Application No.: 10/608,671

Amendments to the Drawings:

ANNOTATED MARKED-UP DRAWINGS

Fig. 1b

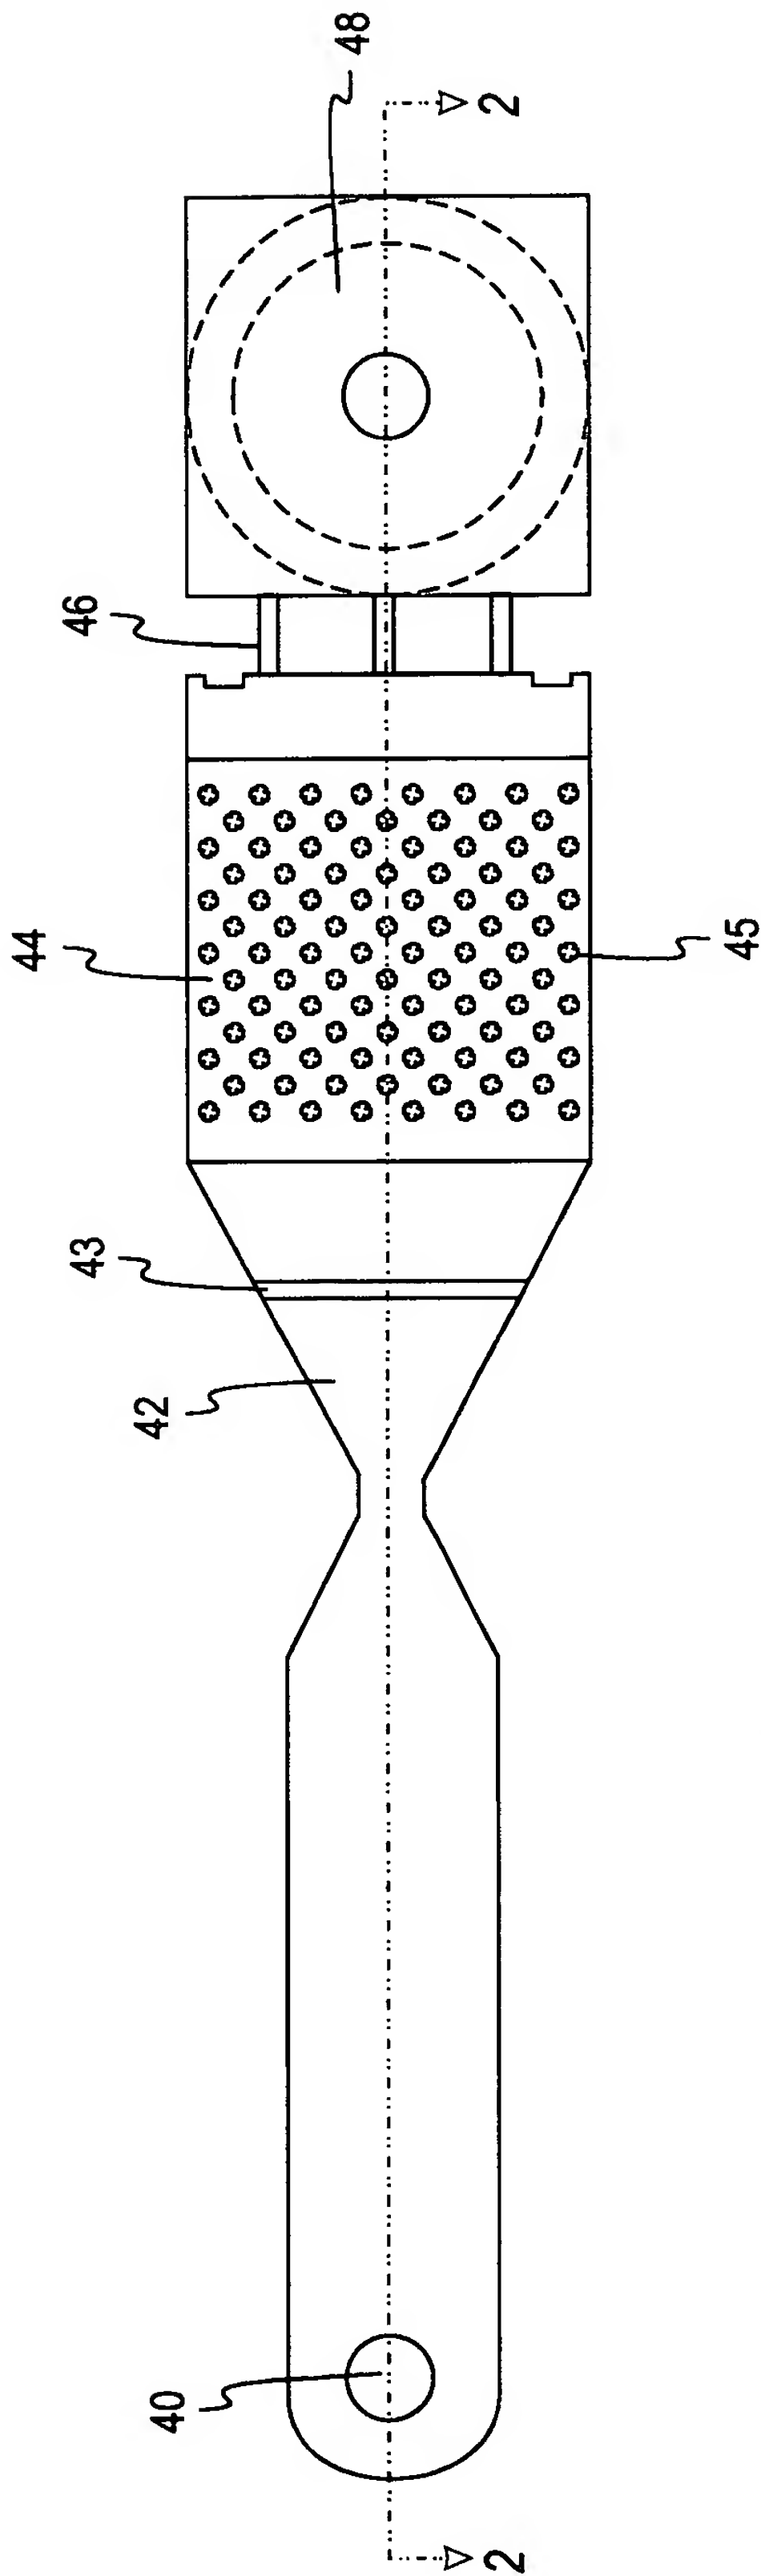
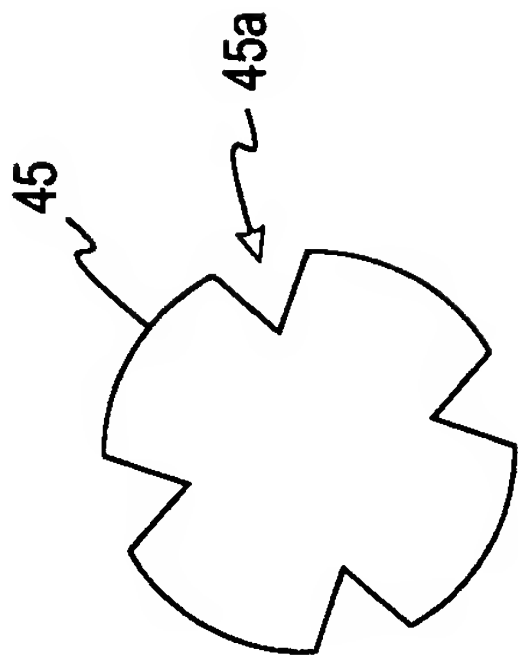
Please replace Fig. 1b-c with the enclosed replacement sheet.

Corrected drawings are attached in compliance with 37 C.F.R. 1.121(d). Corresponding marked-up sheets, showing the revisions in red are included. No amendments to the specification are believed to be needed. Section marks have been added to Fig. 1b and Fig. 2 has been revised accordingly. It is believed that the unidirectional capillary passageway 42, extending from inlet 40 to the inlet chamber 44 is clearly shown in Fig. 1b and Fig. 2. Fig. 3a-c merely illustrate schematically alternatives to the structure of Fig. 2, as discussed on page 8 of the specification.

Fig. 2

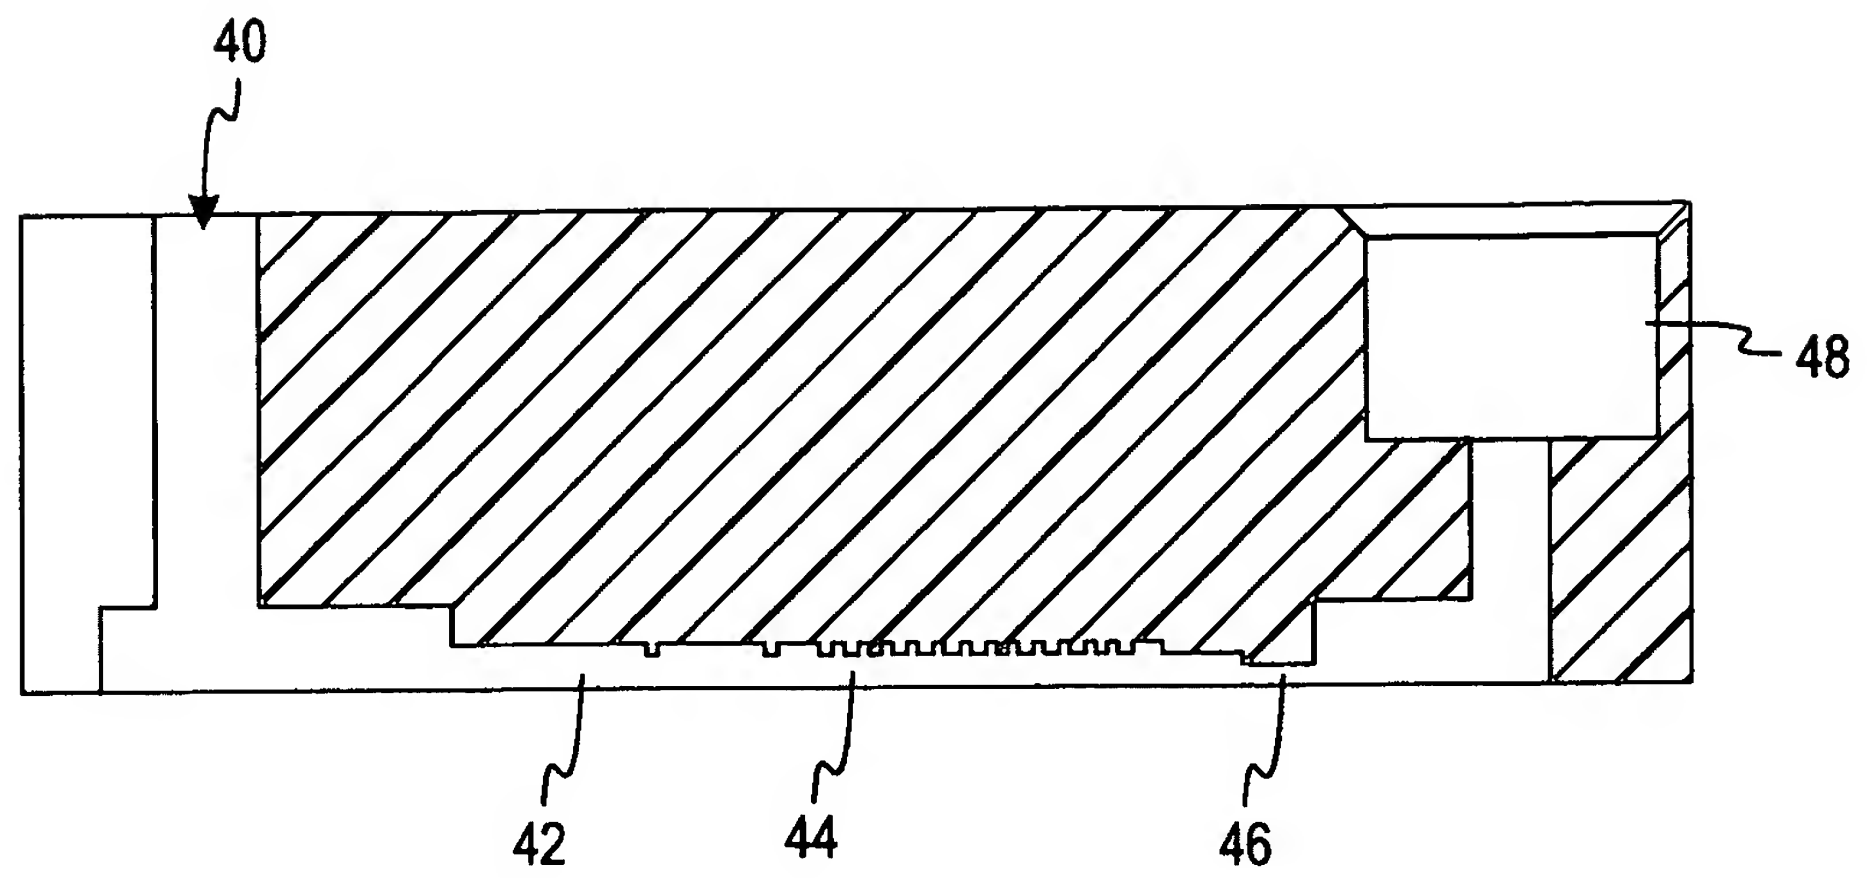
Please replace Fig. 2 with the enclosed replacement sheet.
